CP-201101038
TXX-11093

SUBJECT: COMANCHE PEAK NUCLEAR POWER PLANT (CPNPP) DOCKET NOS. 50-445 AND 50-446, LICENSE AMENDMENT REQUEST (LAR) 11-001, APPLICATION FOR TECHNICAL SPECIFICATION CHANGE REGARDING RISK-INFORMED JUSTIFICATION FOR THE RELOCATION OF SPECIFIC SURVEILLANCE FREQUENCY REQUIREMENTS TO A LICENSEE CONTROLLED PROGRAM

- Attachments
1. Description and Assessment
 2. Documentation of PRA Technical Adequacy
 3. Proposed Technical Specifications Changes (Markup)
 4. Proposed Technical Specifications Bases Changes (Markup for Information Only)
 5. Retyped Technical Specification Pages
 6. Retyped Technical Specification Bases Pages (For Information Only)
 7. Proposed No Significant Hazards Consideration
 8. TSTF-425 (NUREG-1431) vs. CPNPP TS Cross Reference

By this letter, Luminant Generation Company LLC (Luminant Power) requests an amendment to the Comanche Peak Nuclear Power Plant (CPNPP) Unit 1 Operating License (NPF-87) and the CPNPP Unit 2 Operating License (NPF-89) by incorporating the attached change into the CPNPP Unit 1 and 2 Technical Specifications (TS). Proposed change LAR 11-001 is a request to revise the TS for CPNPP Units 1 and 2.

SR 3.4.9.2

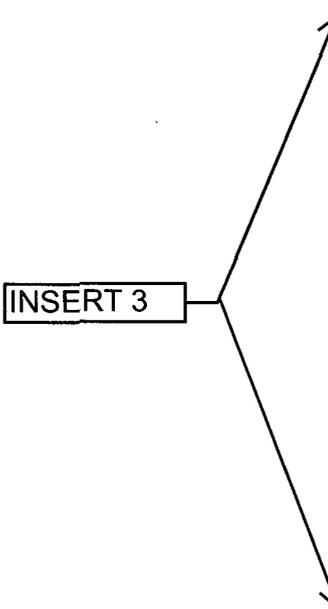
The pressurizer heaters used to satisfy the pressure control function are comprised of one proportional control group and three backup groups. The heater groups are normally connected to the emergency power supplies (two to each Class 1E train of emergency power) and normally operate. The SR is satisfied when the power supplies are demonstrated to be capable of producing the minimum power and the associated pressurizer heaters are verified to be at their design rating. This may be done by testing the power supply output and by performing an electrical check on heater element continuity and resistance. This may also be done by energizing the heaters and measuring circuit current. ~~The Frequency of 18 months is considered adequate to detect heater degradation and has been shown by operating experience to be acceptable. The heater design and operation is consistent with the basis for an 18 month surveillance described in Section 6.6 of Ref. 3.~~

INSERT 3

SR 3.4.15.3, SR 3.4.15.4, and SR 3.4.15.5

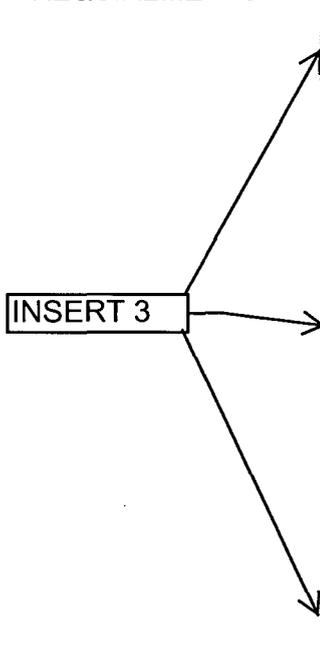
These SRs require the performance of a CHANNEL CALIBRATION for each of the RCS leakage detection instrumentation channels. The calibration verifies the accuracy of the instrument string, including the instruments located inside containment. ~~The Frequency of 18 months is a typical refueling cycle and considers channel reliability. Again, operating experience has proven that this Frequency is acceptable.~~

INSERT 3

SR 3.7.8.3

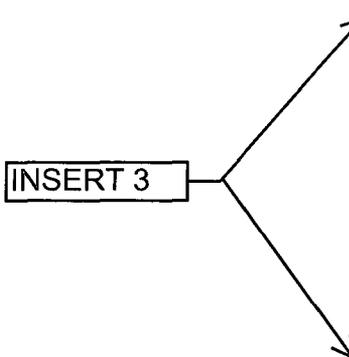
This SR verifies proper automatic operation of the SSWS pumps on an actual or simulated Safety Injection actuation signal. The SSWS is a normally operating system that cannot be fully actuated as part of normal testing during normal operation. ~~The 18 month Frequency is based on the need to perform this Surveillance under the conditions that apply during a unit outage and the potential for an unplanned transient if the Surveillance were performed with the reactor at power. Operating experience has shown that these components usually pass the Surveillance when performed at the 18 month Frequency. Therefore, the Frequency is acceptable from a reliability standpoint.~~

INSERT 3

SR 3.9.6.2

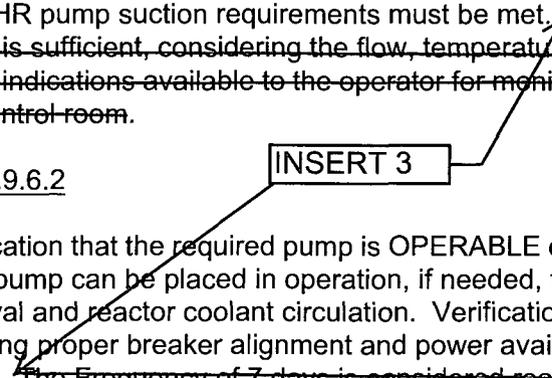
Verification that the required pump is OPERABLE ensures that an additional RHR pump can be placed in operation, if needed, to maintain decay heat removal and reactor coolant circulation. Verification is performed by verifying proper breaker alignment and power available to the required pump. ~~The Frequency of 7 days is considered reasonable in view of other administrative controls available and has been shown to be acceptable by operating experience.~~

INSERT 3
